**Architectural Review Board Staff Report  
February 10, 2025**

**THIRD STREET MIXED-USE DEVELOPMENT  
CERTIFICATE OF APPROPRIATENESS & WAIVERS**

APPLICATION: ARB-98-2024

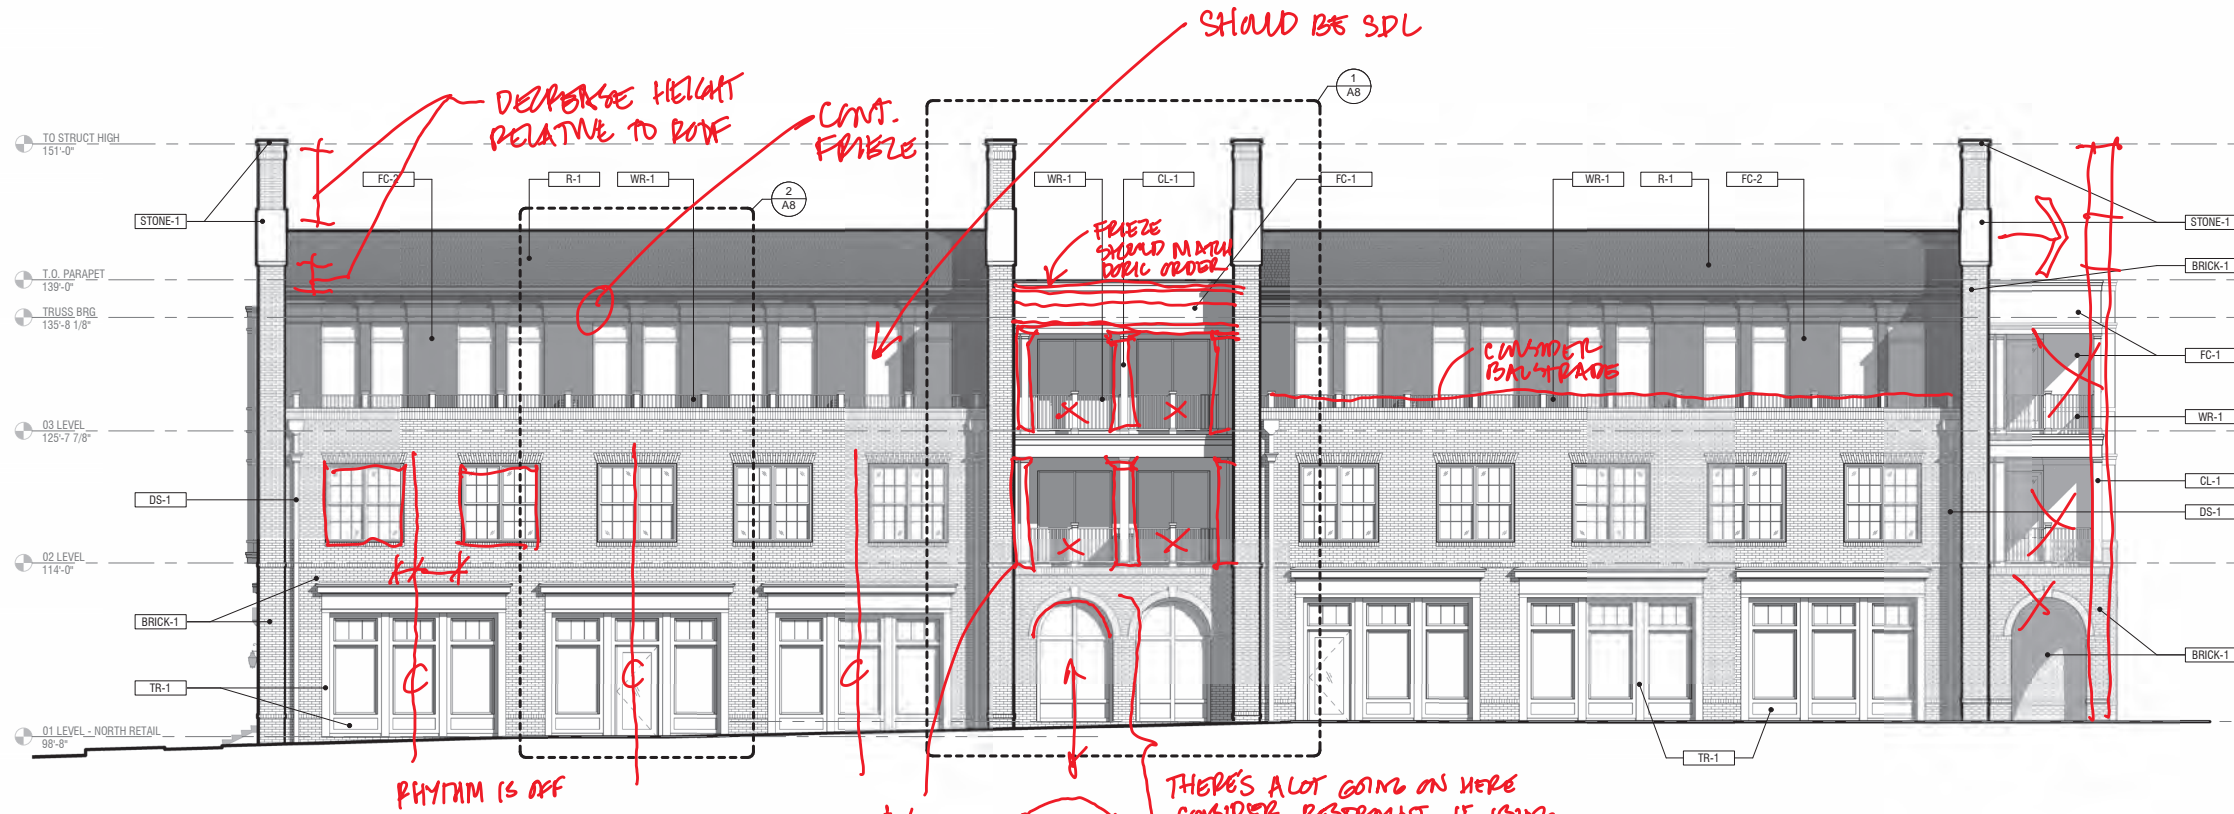
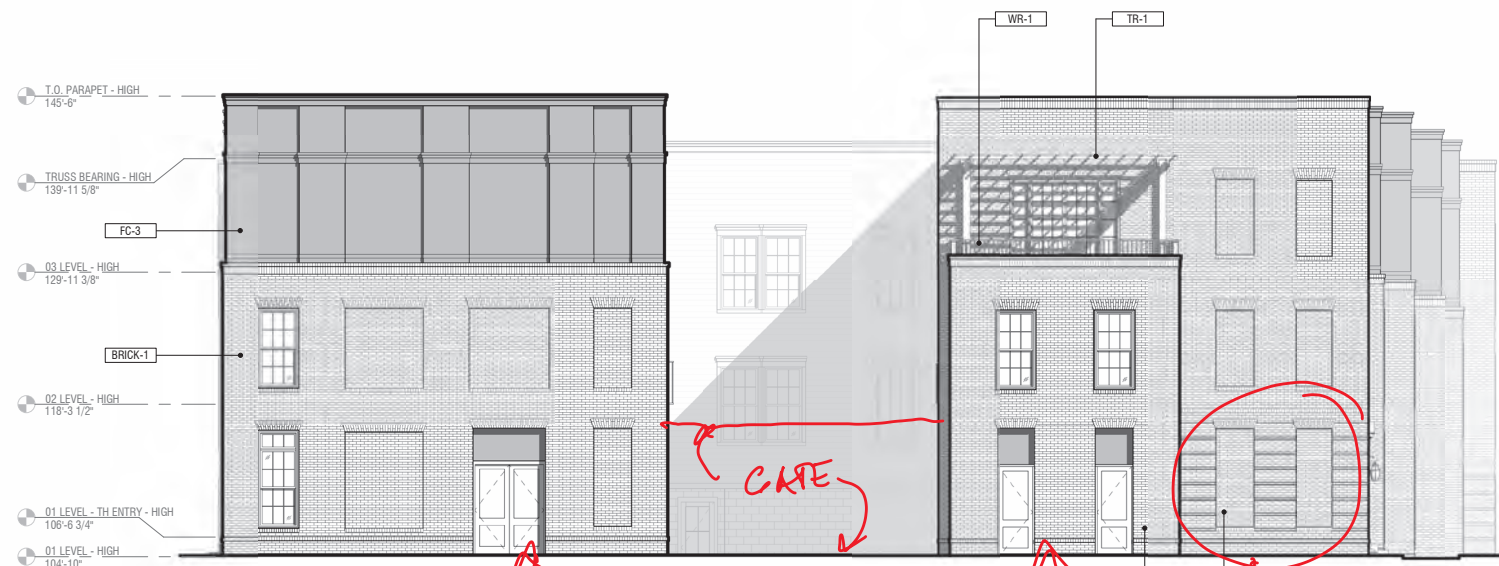
- The covered at-grade patio for a future commercial tenant, previously facing the south property line, has been mirrored across the High Street façade and is now located at the Founder's Way and High Street intersection.
- The two-story balcony element that was previously featured above the commercial patio was converted into to an interior unit space.
  - a. The city architect has evaluated the redesign and states that the end wall parapet elevation needs additional study since it is highly visible. Below is a possible solution. Staff recommends a condition of approval that the applicant enhance the south façade to adhere to a strict centerline, subject to staff approval (condition #1).

- The balconies located centrally on the High Street façade have been eliminated.
- The applicant did not revise the second floor windows to be more centered per Board member Maletz comments however, the city architect supports the current design, as the chosen ordering system results in a balanced elevation.

- This was in response to ARB's concern of the previous location and its appropriateness.
  - As we studied the High Street plan and streetscape further, the development team determined that locating the patio felt more natural and allowed the development to celebrate this new, important intersection.

**2 SOUTH ELEVATION BUILDING ELEVATION**  
SCALE 1/8" = 1'-0"

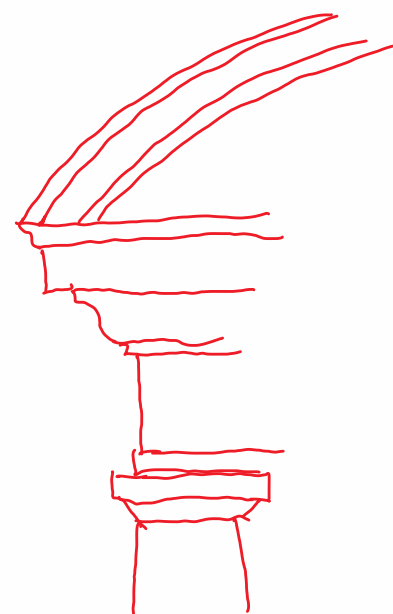
1. That the applicant enhances the south façade to adhere to a strict centerline, subject to staff approval.
2. That the use of hardi-board siding design details be subject to staff approval for sub parcel A, B, and C.
